Subject: Environmental Impact Statement - 225-245 Martin Road, Bradfield Bulk Earthworks (SSD-97711727) (Liverpool City)

CPHR comments on the Environmental Impact Statement - 225-245 Martin Road, Bradfield Bulk Earthworks (SSD-97711727) (Liverpool City)

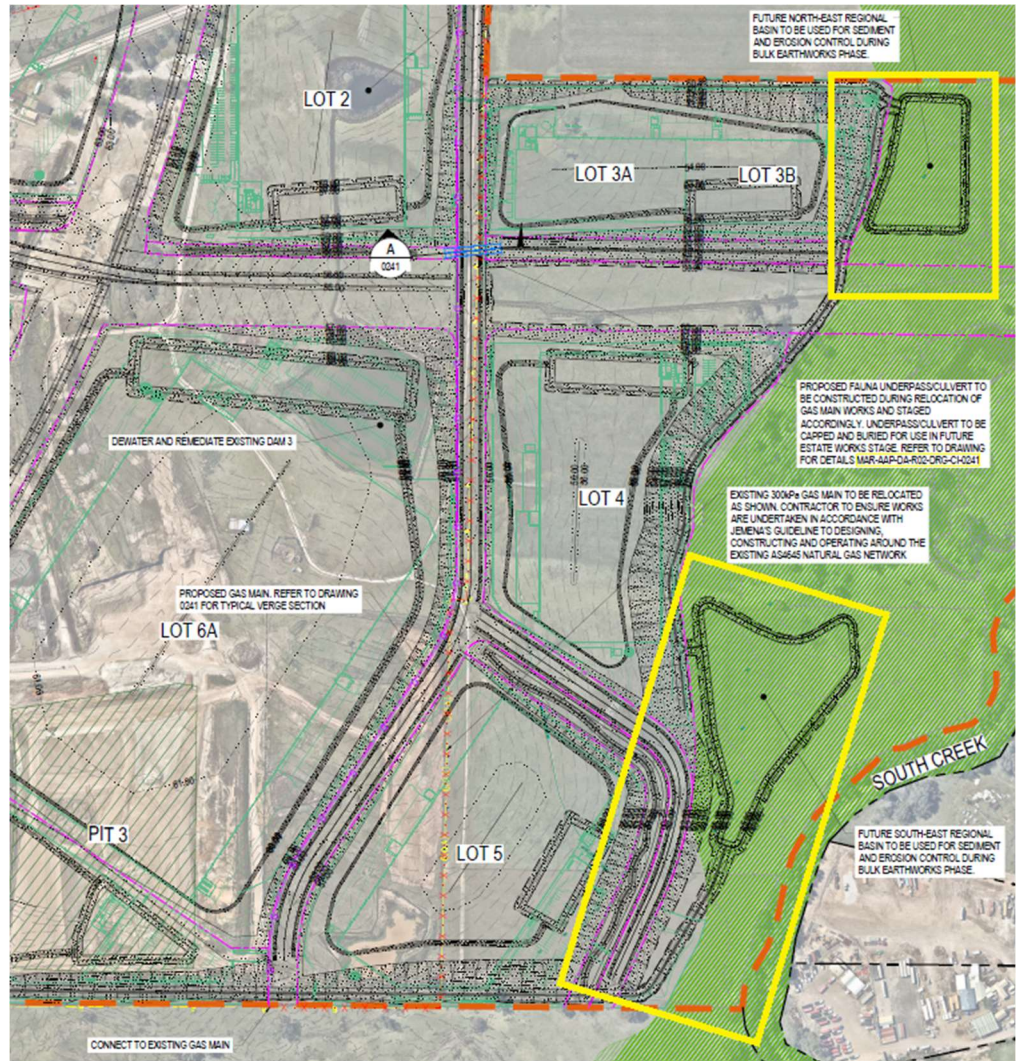
1.	The BDAR Subject Land development footprint does not reflect this proposal	The Biodiversity Development Assessment Report (BDAR) defines the development footprint as the 'Subject Land' which is both the construction footprint and operation footprint of the project in the non-certified portion of the site. The Subject Land identified in Figure 5 the BDAR (as outlined in red on the extract below) does not accurately reflect the development footprint of this State significant development (SSD) application for bulk earthworks but instead reflects the development footprint of the separate Internal Works SSD (SSD-97688711).  The Subject Land in the BDAR is a different shape and size than that depicted in the civil plans extracted below (see yellow outline). Additionally, the BDAR does not include an assessment of the protected existing native vegetation (ENV), a portion of which adjoins the Subject Land, which may be directly or indirectly impacted by the development.

- Update the BDAR to reflect the accurate development footprint for this SSD application.
- The BDAR is to identify all ENV in the non-certified land and demonstrate that there will be no direct or indirect impacts.

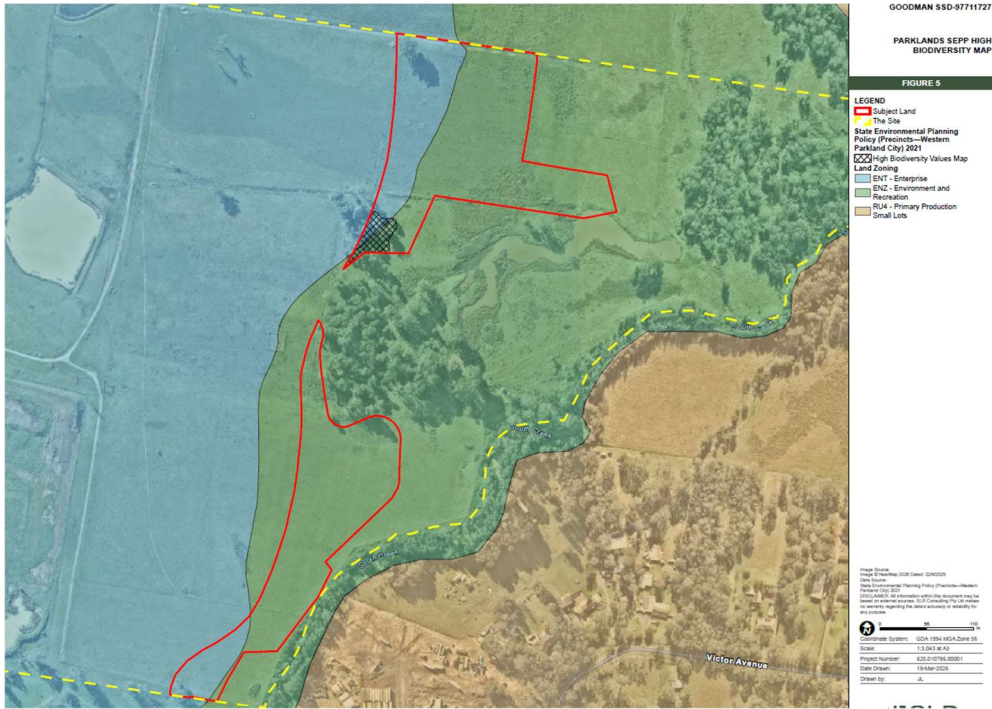
While Clauses 4.25 and 4.25A have been addressed in the Compliance Table and BDAR, this is limited only to the protected ENV identified in the Subject Land which does not accurately reflect the development footprint of this proposal. This assessment is considered inadequate as it has not considered the full extent of protected ENV in the non-certified land.

As noted above, the 'Subject Land' footprint assessed in the BDAR does not accurately reflect the development footprint of this SSD, and there is protected ENV directly adjoining Subject Land which has not been assessed. Recommended actions: - Clearly map all protected ENV on non-certified land as identified in the WPC SEPP and Precinct Plan, including those areas outside of the development footprint. - Demonstrate that the development will not directly or indirectly impact on protected ENV. - Update the civil plans to show the areas of protected ENV and provide cross-sections and levels where there is adjoining development and demonstrate an adequate buffer. Specifically, the north-east and south-east regional sediment and erosion control basins within the ENZ zoned land. - Address the following clauses of the WPC SEPP for the non-certified areas of the site: - clause 4.25 which applies to preservation of trees and vegetation in land in the ENZ or shown as ENV on the High Biodiversity Value Areas Map (both of which apply in this instance) - clause 4.25A which applies to the clearing of land shown as ENV on the High Biodiversity Value Areas Map. - Address Section 4.5.4 of the Precinct Plan, ensuring that the development footprint is accurately depicted in the BDAR, and that all ENV has been clearly mapped.

Figure 7 of Precinct Plan - Protected Existing Native Vegetation and Protected areas under the Cumberland Plain Conservation Plan (yellow outline shows the area of protected ENV in non-certified land)

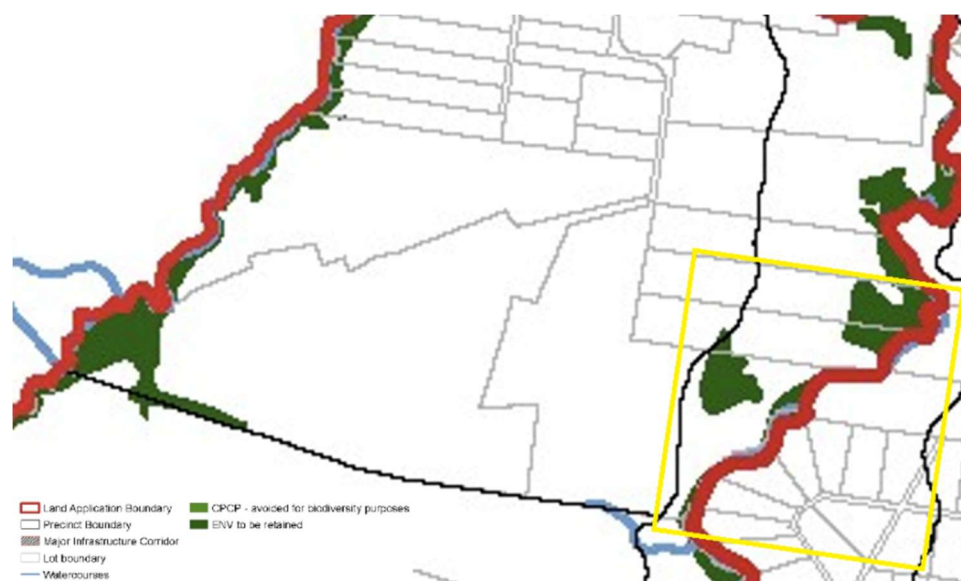
Section 4.5.4 of the Precinct Plan requires the protection of ENV, which has been addressed in the Statutory Compliance table submitted with the EIS and refers to the BDAR.

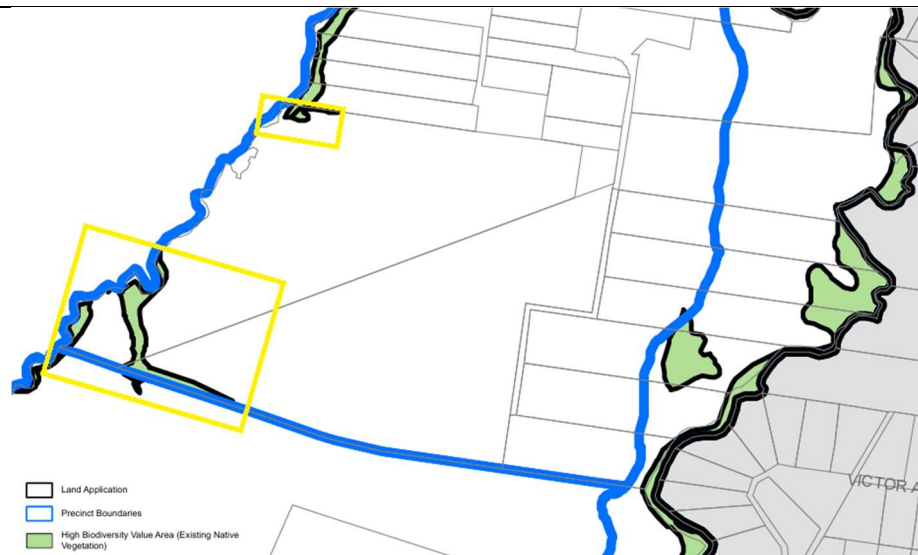
CPHR notes that these clauses of the WPC SEPP have been addressed in the BDAR, this relates only to the non-certified land. These clauses are required to be addressed for all the protected ENV including the protected ENV located in certified land.

Section 4.5.4 of the Precinct Plan has not been assessed for the certified land. Recommended action: • Address the relevant biodiversity measures of the Order. • Clearly map all protected ENV on certified land as identified in the WPC SEPP and Precinct Plan. • Demonstrate that the development will not directly or indirectly impact on protected ENV. • Update the civil plans to show the areas of protected ENV and provide cross-sections and levels where there is adjoining development and demonstrate adequate buffers are provided. • Address the following clauses of the WPC SEPP: ○ clause 4.25 which applies to preservation of trees and vegetation in land in the ENZ or shown as ENV on the High Biodiversity Value Areas Map (both of which apply in this instance) ○ clause 4.25A which applies to the clearing of land shown as ENV on the High Biodiversity Value Areas Map. • Address Section 4.5.4 of the Precinct Plan, which requires the protection of ENV. • In relation to the protected ENV land on the southern boundary: ○ provide details as to the ownership and management arrangements of the protected ENV and which is shown as being outside Lot 12, and isolated by the proposed road crossing the south-western boundary ○ provide details of setbacks (including from the indicative retaining wall footings) and extent of the buffers to the protected ENV land from the adjoining development within the site (Lot 12) ○ provide detailed cross-sections and levels (including any retaining walls and batters) of the protected ENV land and surrounding development including: ▪ the levels of the building pad for Lot 12 ▪ the proposed north-south road which crosses the protected ENV at south-western boundary to connect to the IPG land ▪ the proposed road within the IPG Badgerys Creek Road Masterplan which is parallel to the protected ENV to the south.

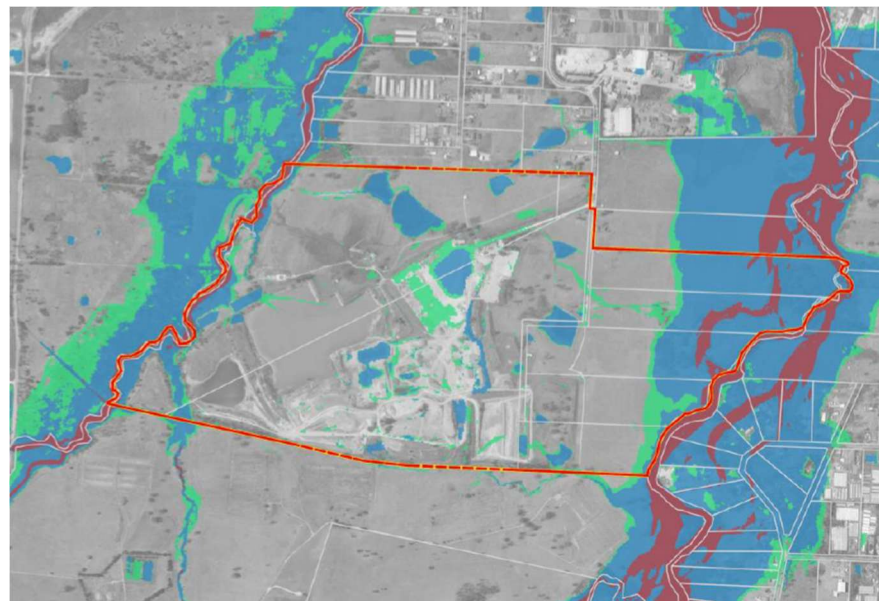
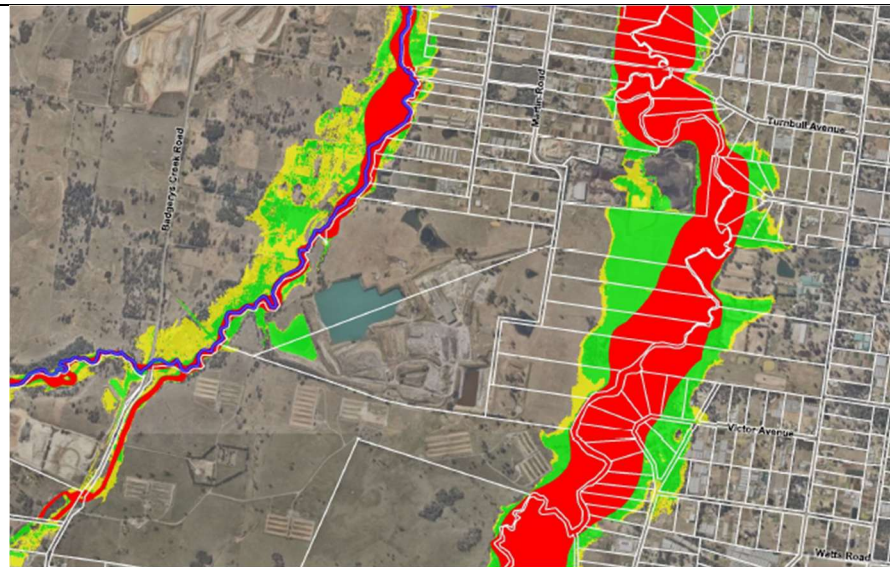
12.	Verification of FIRA Models for existing scenario	The Flood Impact and Risk Assessment (FIRA) report should provide a section to show compatibility with the Wianamatta South Creek Flood Study – Existing Conditions (Advisian, 2022). The FIRA modelling must maintain the hydraulic function as identified in the Wianamatta South Creek Flood Study – Existing Conditions (Advisian, 2022) as set in the Benchmarks in the Aerotropolis DCP. The FIRA Figure 3-13 show significant inconsistency between the flood function categories identified by the FIRA and the above-mentioned Wianamatta South Creek flood study.
-----	---	---

- Verify the existing case scenario with the Wianamatta South Creek Flood Study – Existing Conditions (Advisian, 2022).

Provide amended maps for flood function that are consistent with the Wianamatta South Creek Flood Study – Existing Conditions (Advisian, 2022).
	<i>Extent and Timing</i>	Prior to determination.
